March 2020 Med Tips

SERVICE BULLETIN - CLEANING AND DISINFECTION OF CAIRE CONCENTRATOR AND LOX EQUIPMENT

PRODUCT UPDATES

Figure 1.7

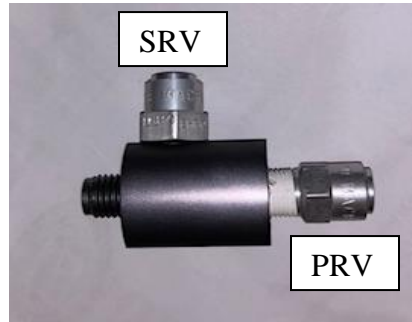
- 1.7 Remove the Secondary Relief Valve (SRV) from the FCV with a 9/16 Wrench (make sure threads are clean) and attach to the Street Tee fitting (PN 21385560), torque SRV to 80-90 in/lb when reinstalling. Remove the PRV from the plumbing with a ½ Wrench, clean off threads, apply new Teflon tape leaving the 1st thread bare, and attach to the Street Tee fitting.

Figure 2.2

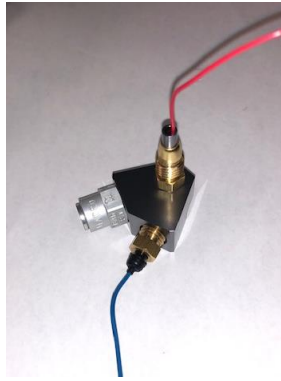
- Note:** Save the SRV from the old FCV for step 2.2
- 2.2 Assemble the SRV onto the Manifold Tee (PN 21237266), which will come with Fitting Feedthru (PN CA404841) and Ferrule (PN B-775068-00) already attached, tighten to 80-90 in.-LB. The wire harness assembly will be threaded through the Manifold Tee by the red wire. Manifold tee assembly will be needed in step 2.6.

- Note:** Feed the red wire through. Do not pull on the wire or it could strip the insulation of the wire.

Updated Eclipse 5 Touch Panel

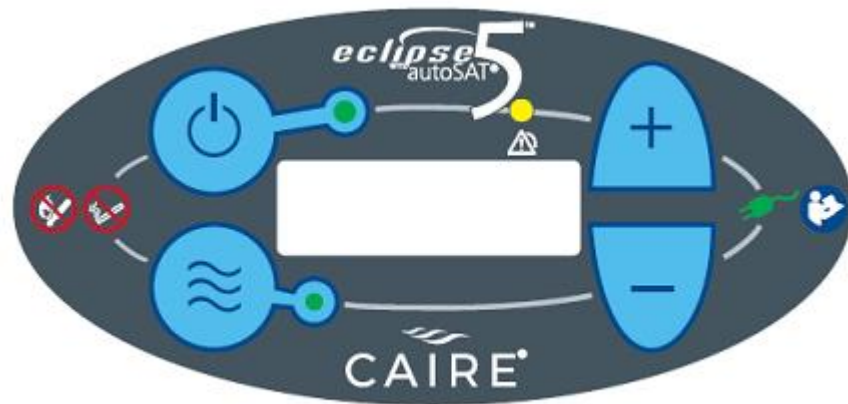
NOTES: To ensure Eclipse devices are compliant with the IEC 80601-2-69 (including IEC 60601-1 edition 3.1 and EMC IEC 60601-1-2 4th edition), coming in 2018 the Eclipse 5 will no longer have a red alarm indication. This change will be accompanied by a revised touch panel, new circuit board part number, and an updated alarm code troubleshooting tables.

With the new display panel, there will no longer be a red indication for an alarm code. The new panel will display a yellow LED, audible alarm, and an associated fault code.
